RE: Proposed Rezoning of 303 West Eleventh Street, Lawrence, Kansas

Re: *Draft Oread Neighborhood Design Guidelines (the “Guidelines”)*

**Subject:** FW: duplex tandem parking in core neighborhoods

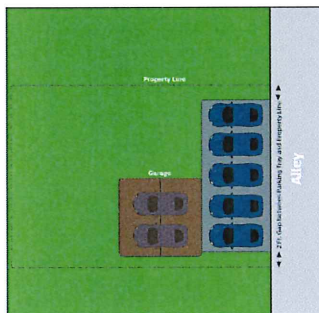
**4. The parking configuration depicted below should be re-inserted in the Guidelines because it is not “double-stacking.” This design should be an option in appropriate circumstances, determined on a case-by-case basis.**

It is unfair to completely eliminate today the possibility of allowing a Duplex more than five parking spaces in the future, especially for those properties that have been redeveloped since the adoption of the Code in 2006. The most recent draft of the Guidelines permit two limited configurations that effectively limit parking to five spaces on any Detached Dwelling or Duplex, and eliminates the only seven-car option.<sup>1</sup> The above configuration, which permits a two car garage and five outside spaces, should be re-inserted because (aesthetically, at least) it's not “double-stacking” if a garage door separates the cars. On a “case-by-case” basis, that configuration may be appropriate in the future.
